RE: Impact of Wintertime SCR/SNCR Optimization on Visibility  
Impairing Nitrate Precursor Emissions, August 29, 2017.

COMMENTS ON MANE-VU MEMO ENTITLED

“WINTERTIME SCR/SNCR OPTIMIZATION ON VISIBILITY IMPAIRING NITRATE PRECURSOR EMISSIONS”<sup>1</sup>  
September 29, 2017

Figure 1. National, annual NOx emission trends by source sector.

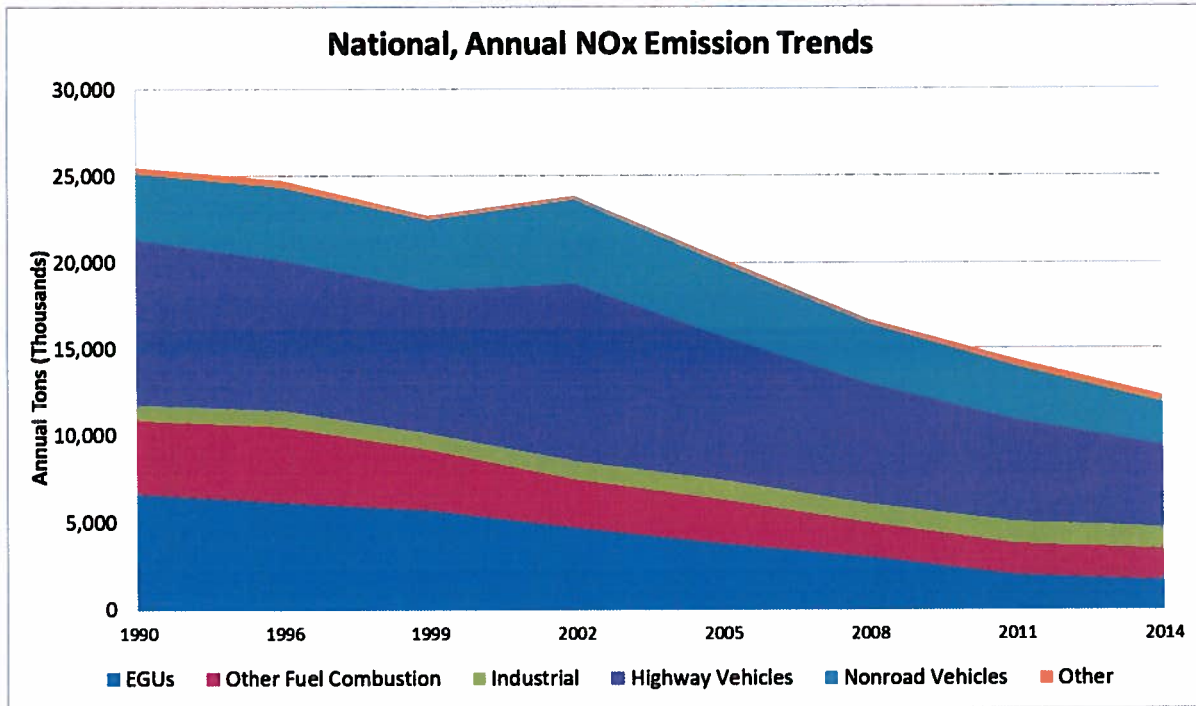
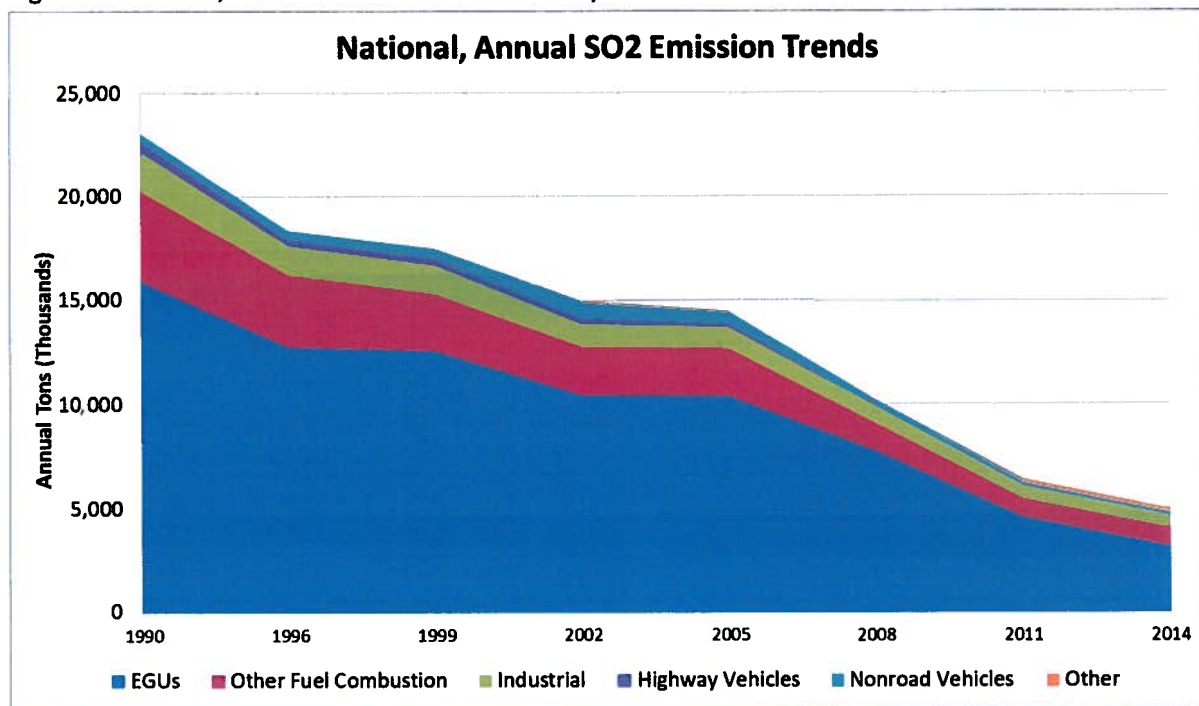
MANE-VU offers no analyses about whether the control strategy it advances would help Brigantine in any meaningful way achieve its appropriate glidepath goal in 2028. Brigantine is, of course, the only Class I area in MANE-VU that is projected not to meet reasonable progress goals in 2028. For example, Figures 1 and 2, showing NO<sub>x</sub> and SO<sub>2</sub> emission trends, depict how these emissions have changed over time on a national basis. Comparing EGU SO<sub>2</sub> and NO<sub>x</sub> emission trends (Figures 3 and 4) and sulfate contribution trends at Brigantine (Figure 5), we see that there is a direct correlation in the reduced contribution of sulfates to impairment and EGU SO<sub>2</sub> emission reductions. In contrast, as

Figure 3. National, annual EGU SO2 emission trends (2000-2016).

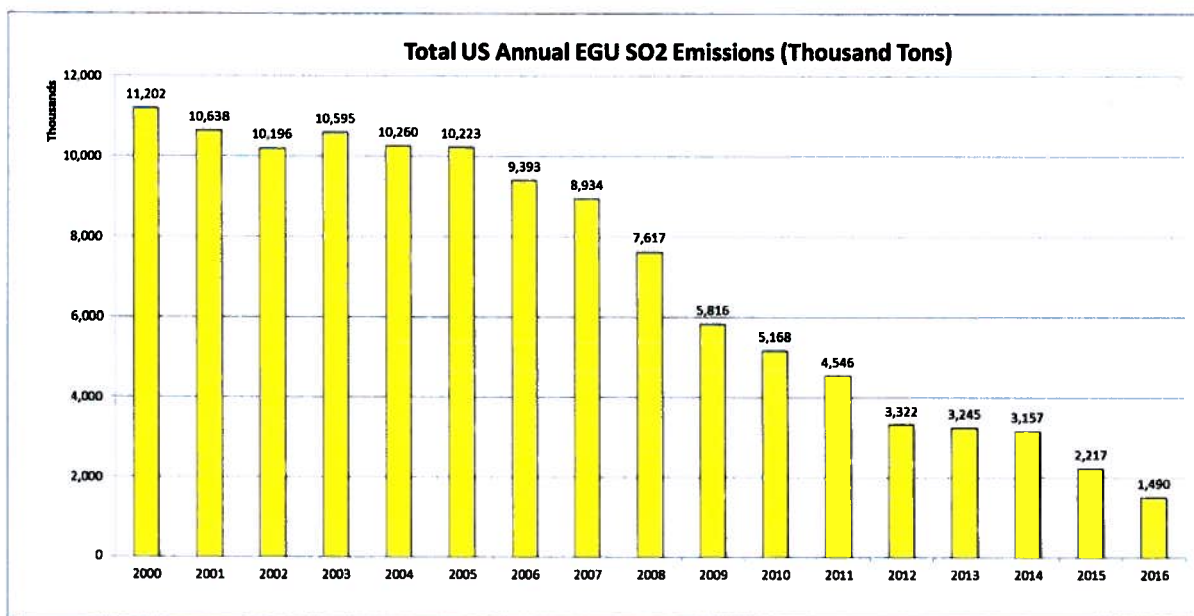
As seen in Figure 3 below, the most significant EGU SO2 reductions have occurred since 2014, but the MANE-VU memo doesn't address them. 2016 includes SO2 reductions for MATS acid gas and 2016 SO2 tonnage is less than half of what was emitted in 2014. Non-ozone season NOx in 2017 could remain at the 2016 level, 660,000 tons, but annual emissions will be down due to the CSAPR Update budget and PA RACT II. The non-OS NOx in 2016 is about 33% lower than in 2014. Interestingly, the ozone season and non-ozone season NOx split is very close to the 5 month/7 month split of the total. These data significantly call into question the MANE-VU conclusion that national 2016 EGU SO2 emissions of about 1.5 million tons are not a major source of visibility impairment, but EGU NOx annual emissions of 1.2 million tons are a major contributor.

Figure 6. Brigantine NWR Light Extinction and National Emission Inventory Trends

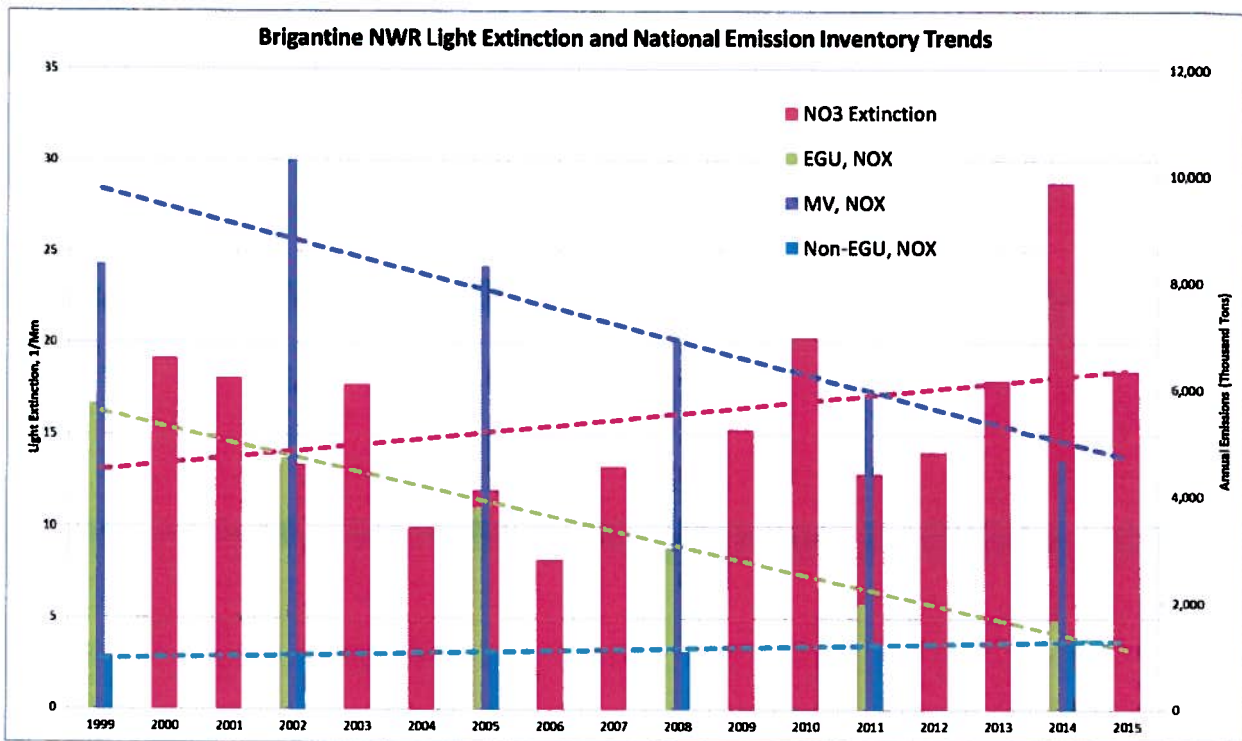
demonstrated in Figure 6, there is a negative correlation between EGU NOx emissions and nitrate contributions during those same periods (EGU NOx decreases and nitrate contribution increases). However, a positive correlation is noted between non-EGU industrial source NOx and nitrate contributions to visibility impairment, but MANE-VU hasn't analyzed impairment by that sector, instead focusing only on EGUs.

Figure 7. Extinction budget by group, 2015, Brigantine NWR.

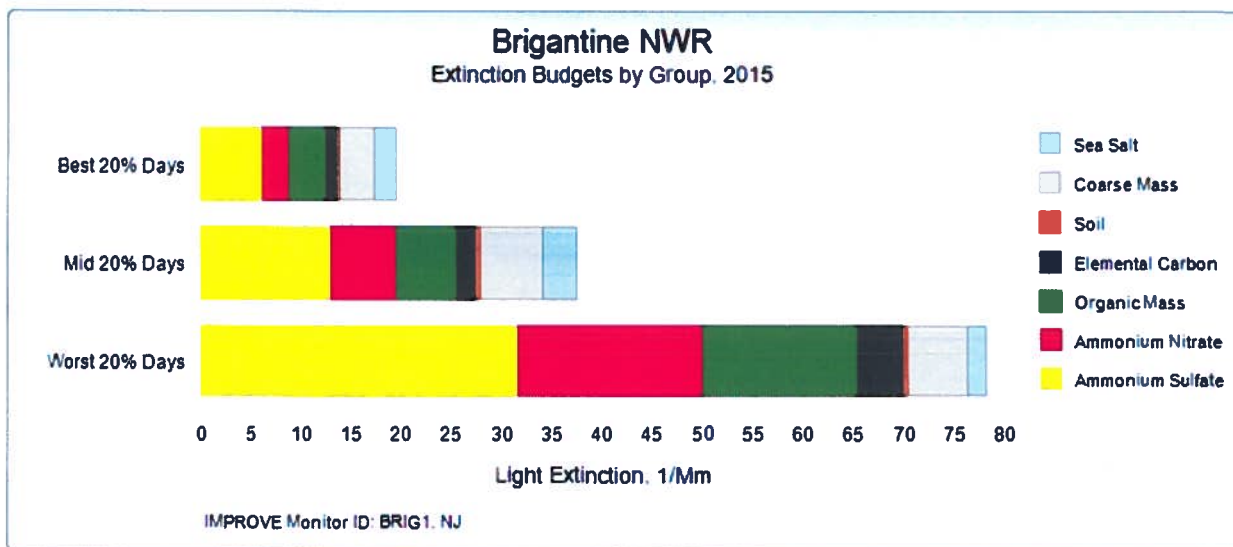
Furthermore, visibility impairment in the northeast is still largely based on sulfate contributions for both the worst and best 20% visibility days. Figure 7 shows extinction budgets by group for 2015 at the Brigantine NWR receptor. And as is demonstrated in further sections of this response, for the noted days when nitrate is the primary contributor to light extinction at this location, NOx emissions are attributed to local EGU operations or to international emission sources, either anthropogenic or natural.

Figure 8. Daily light extinction budgets, Brigantine NWR, 2015.

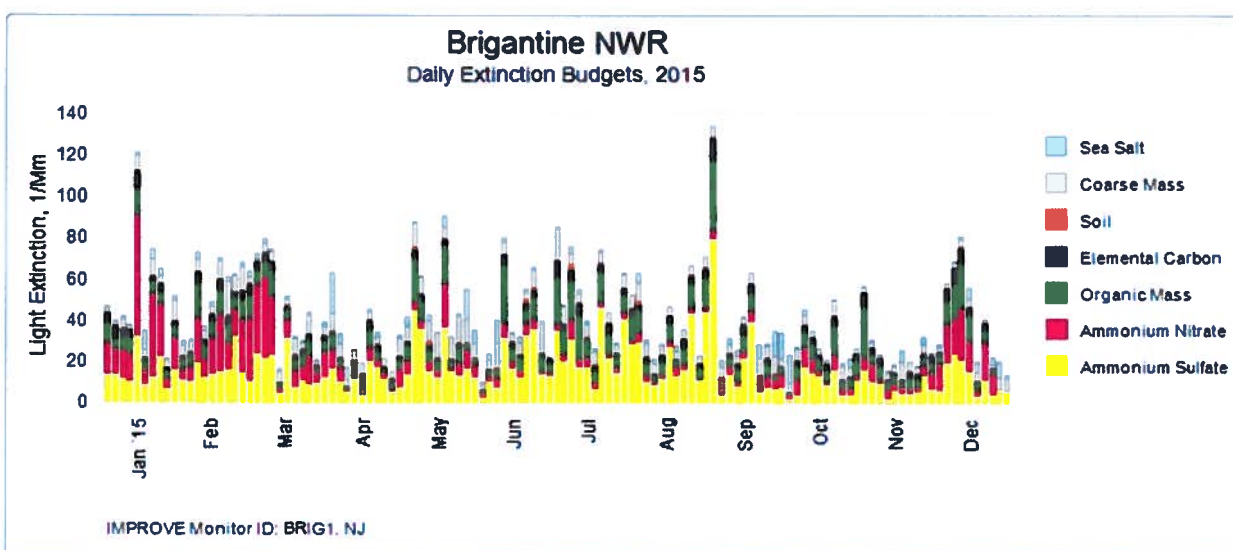
Figures 6 through 10 of the MANE-VU memo demonstrate the widely-reported observation that sulfates have historically driven visibility impairment in the northeast. Recent observations (Figure 8) at the Brigantine NWR now demonstrate an increased contribution of nitrate during the early year winter months of 2015 and for a percentage of the worst 20% (W20%) visibility days at the Class I area. As noted in item 3. above, SO<sub>2</sub> emissions from EGU control nationwide have decreased and so has the contribution of sulfate to visibility at many Class I areas in the eastern U.S. In its memo, MANE-VU attributes this increased contribution of nitrates to non-OTC regions using simple back trajectory maps and emission summaries and projections.

Figure 9. Reported CEM average monthly EGU NO<sub>x</sub> emission rates for 2015 by RPO (Source: CAMD data download).

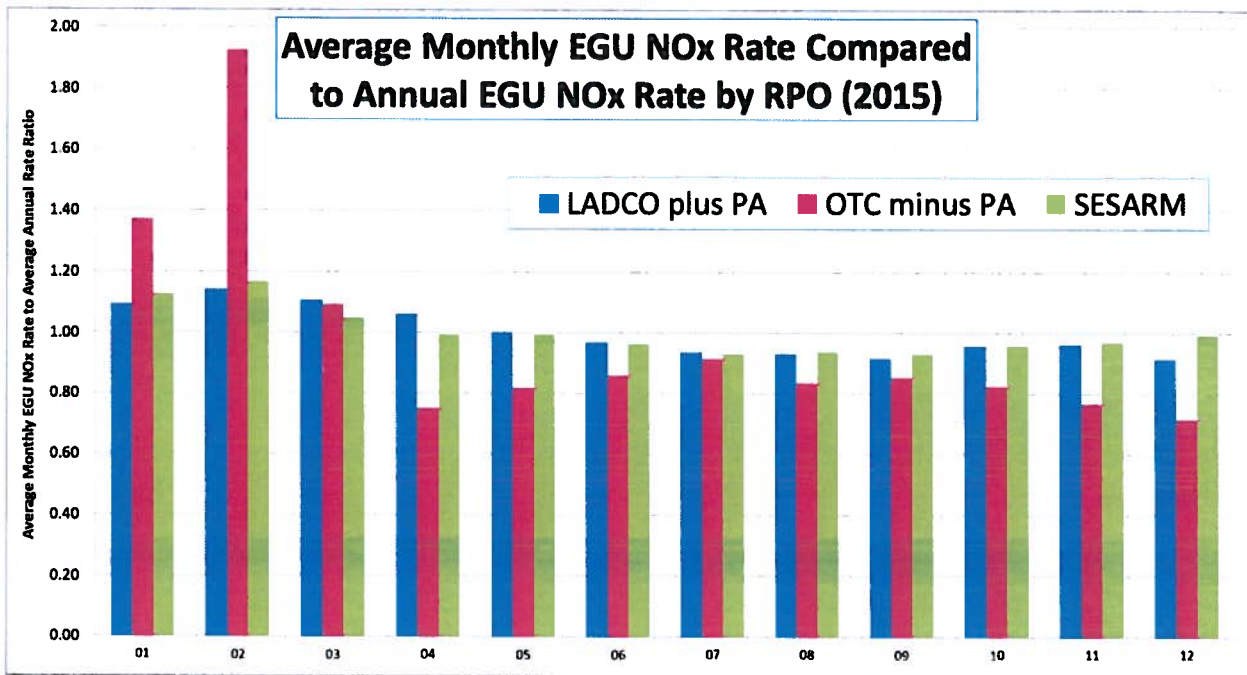
Focusing on reported 2015 monthly CEM NO<sub>x</sub> data by unit, aggregated to RPO, we see in Figure 9 that for the months that MANE-VU has indicated nitrate has displaced sulfate in the W20% calculation list (Jan, Feb, and Mar), OTC EGU (minus PA) collectively operate at higher emission rate ratios than in the other months and seasons and that correlate to nitrate contribution light extinction budgets for the same periods. Comparably, EGUs from other upwind RPOs (plus PA) demonstrate consistently lower emission rate ratios during this same time period and consistent average operating rates during the course of the year, raising the question whether the increased emission rates seen in the OTC during January and February of 2015 are driving the nitrate-based visibility impairment during those same months at Brigantine NWR.

Based on these data, it is apparent that MANE-VU is incorrect in its conclusion that nitrates from EGUs outside its own state borders are the most significant contributor to visibility impairment in MANE-VU.

Figure 10. Trajectory analyses of Brigantine 20% most impaired days during Winter 2015 (Source: Figure 14, MANE-VU Winter NOx Control Memo 170905).

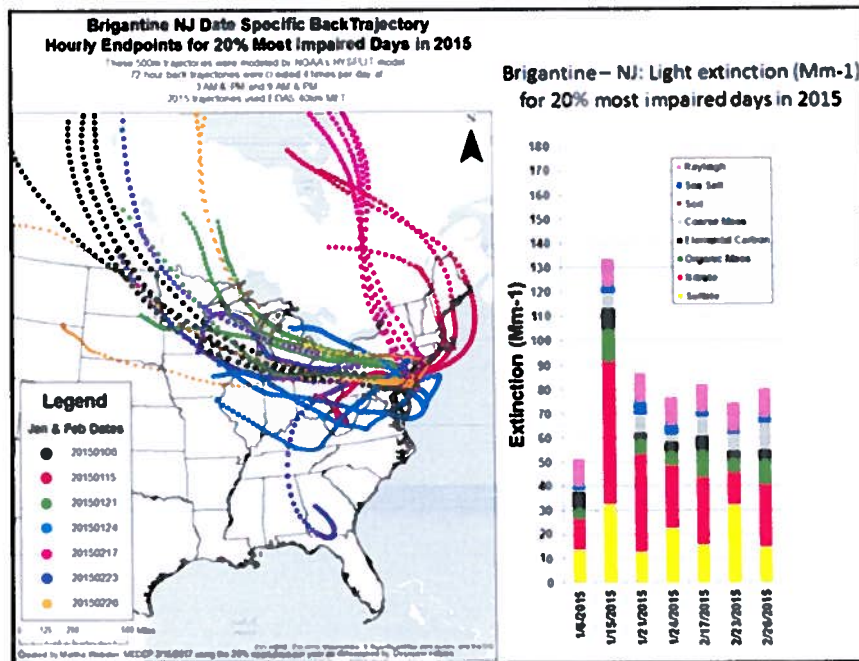
Based on Figure 14 of MANE-VU’s memo (also included as Figure 10 here), the back trajectory analysis for the 20% most impaired days during winter 2015 at Brigantine NWR includes a majority of days where there is a demonstrated northern wind pattern out of Canada that brings anthropogenic and natural emission contributions of international origin. In fact, two of the three highest days of light extinction (January 15<sup>th</sup> and February 17<sup>th</sup>) have a direct trajectory from the north while passing over

New York and Maine, respectively, on the path to the Brigantine NWR receptor. With the exception of January 24<sup>th</sup>, it appears that all other winter visibility impaired days also have at least one daily origin track back into Canada and locations north of the continental U.S. indicating an international contribution to the light extinction observations.
